**NUMBER:** 18-048-20 REV. A

Flash: Powertrain Control Module (PCM) Updates

This bulletin involves reprogramming the Engine Control Module/Powertrain Control Module (ECM/PCM) with the latest available software.

| <b>**2020</b> | (DJ) | RAM 2500 Pickup <b>**</b> |

Fig. 2  
Old Style Asymmetrical Cam Design Pump

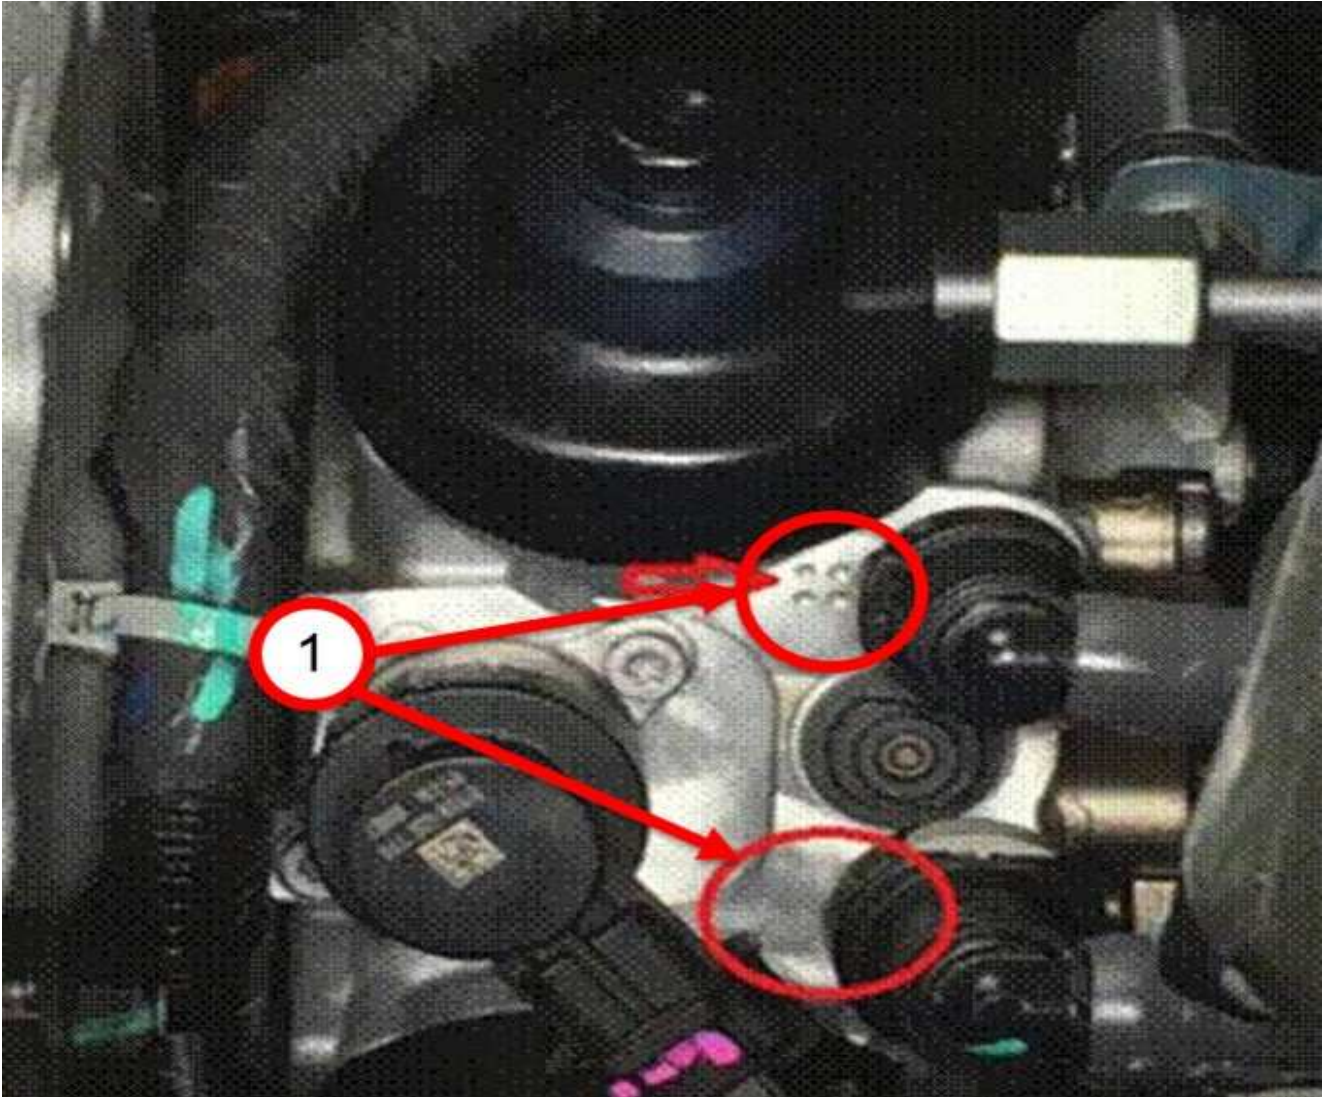
- Vehicles with the old syle Asymmetrical Cam design will have multiple dots embossed in the pump housing (Fig. 2) .
- For vehicles with an Asymmetrical Cam pump, choose the calibration labeled Asymeric Cam or Asym Cam.
